[Docket No. FAA-2013-0023; Directorate Identifier 96-CE-072-AD]

#### Airworthiness Directives; Various Aircraft Equipped With Wing Lift Struts

**ACTION:** Notice of proposed rulemaking (NPRM).

#### Airworthiness Directives; the Boeing Company Airplanes

Figure 1

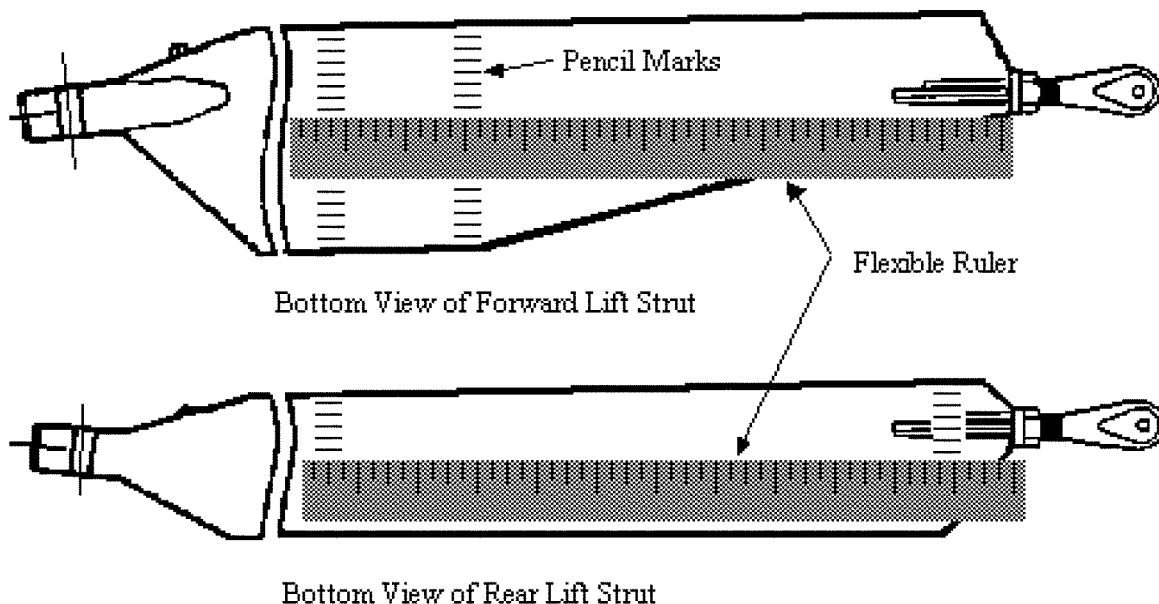
2. Using a flexible ruler, draw a 1/4-inch grid on the surface of the first 11 inches from the lower end of the strut as shown in Piper Service Bulletin No. 528D or 910A, as applicable. This can be done using a soft (#2) pencil and should be done on both faces of the strut. As an alternative to drawing a complete grid, make two rows of marks spaced every 1/4-inch across the width of the strut. One row of marks should be about 11 inches from the lower end of the strut, and the second row should be several inches away where the strut starts to narrow. Lay the flexible ruler between respective tick marks of the two rows and use tape or a rubber band to keep the ruler in place. See Figure 1.
